Access Compliance Report

Public Rights-of-Way

(Curb Ramps)

Intersection ID: 8938	Main Street: NORRIS_AV	Cross Street: NEWLAND_RD	Location: SW
ADA ID: 22EA97DB41AF	Ramp Type: Perp	Initial Pass/Fail: Fail	Overall Compliance: No
Severity Score: 21.25			
Codes/Mitigation Info/Possible Solution		Field Measurements/Component Compliance

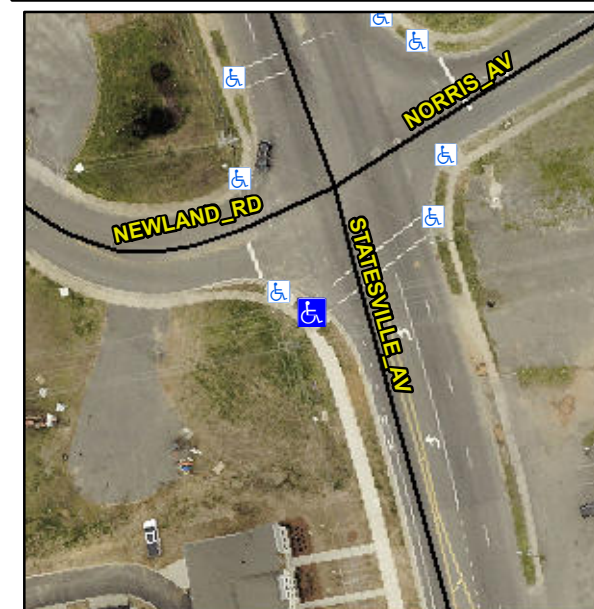
Not Found, R304.5.1, R304.2.2

Compliance	Description	Data	Compliance	Description	Data
N/A	Ramp Length (in)	59.0	No	Ramp Slope (%)	8.5
No	Ramp Width (in)	41.5	Yes	Ramp XSlope (%)	1.6
N/A	Flare Type LT	N/A	N/A	Flare Type RT	N/A
N/A	Flare Slope LT (%)	N/A	N/A	Flare Slope RT (%)	N/A
N/A	Flare Traversable LT?	N/A	N/A	Flare Traversable RT?	N/A
N/A	Landing Length (in)	N/A	N/A	DWS Provided?	N/A
N/A	Landing Width (in)	N/A	N/A	DWS Contrast?	N/A
N/A	Landing Slope (%)	N/A	N/A	DWS Length (in)	N/A
N/A	Landing X Slope (%)	N/A	N/A	DWS Full Width?	N/A
N/A	Landing Curb? (Y/N)	N/A	N/A	DWS Offset (in)	N/A
N/A	Shared Landing?	N/A			
N/A	Gutter Ponding?	N/A	N/A	Gutter Slope (%)	N/A
N/A	Gutter Lip Ht (in)	N/A	N/A	Gutter X Slope (%)	N/A
N/A	Painted X Walk1?	Yes	N/A	Painted X Walk2?	N/A
	X Walk 1 Direction	To NE		X Walk 2 Direction	N/A
N/A	X Walk 1 Width (in)	111.0	N/A	X Walk 2 Width (in)	N/A
	X Walk 1 Slope (%)	3.2		X Walk 2 Slope (%)	N/A
	X Walk 1 X Slope (%)	2.2		X Walk 2 X Slope (%)	N/A

Remove & Replace Entire Ramp.
